Annex IV

June Working Group meeting and teleconference resolution of issues

ATC v 5.2 Notes

Mitretek Notes

Comment:	Why is this statement here?
Item No.	6.
Document:	ATC Standard
Page:	2-2, Line 3
Paragraph	Figure 2-1: Component Parts of the ATC Controller and their Connections.

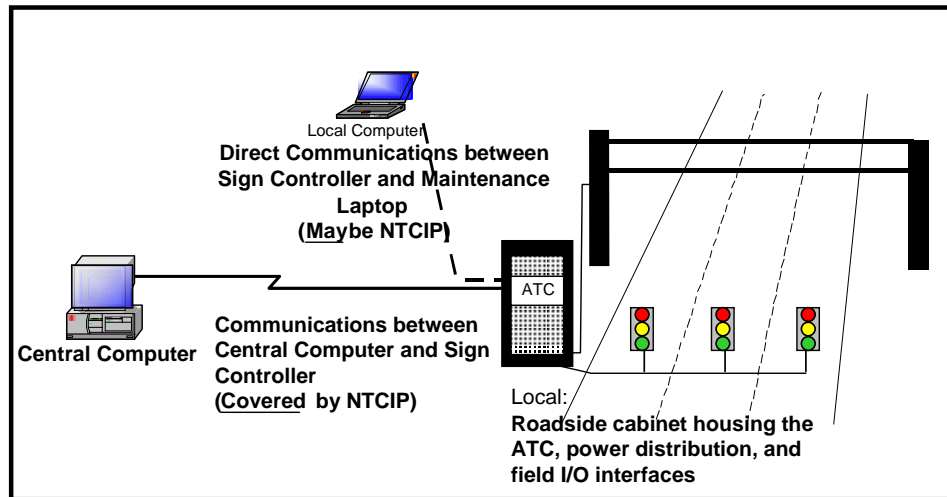
or Item:								
Comment:	This Figure is not in the List of Tables and Figures. The figure is not defined as a “Figure Style” (i.e., from the MS Word menu, Insert -> Reference -> Index and Tables...). This will not show in the List of Tables and Figures when the list is regenerated.							
Item No.	7.							
Document:	ATC Standard							
Page:	2-4, line 9-10 7-1, line 33							
Paragraph or Item:	“In this standard, alternative user interfaces may be included, provided that the minimal or an optional interface is provided, also.”							
Comment:	This is ambiguous as written, “minimal or an optional”. Is the minimal user interface required? The text implies that an optional interface could be provided instead of the minimal interface. Is this the intent? This is inconsistent with section 7.1.2. Section 7.1.2 Optional User Interfaces states, “In addition to the minimum User Interface, the ATC may include one or more optional User Interfaces.”. “In addition to...”, implies that the minimal user interface is mandatory.							
Item No.	8.							
Document:	ATC Standard							
Page:	2-5, line 1							
Paragraph or Item:

22. I added "Heater Power" to Figure 2-1. Also, fixed SP8 as it does not go to the Communication Interface Slot(s).
23. The tolerances previously discussed for POWERUP and POWERDOWN cause a violation of the Short Power Test of 9.10.1. As such I changed the starting point of the timer for the POWERUP signal going low to be from the time of loss of AC Service Power.
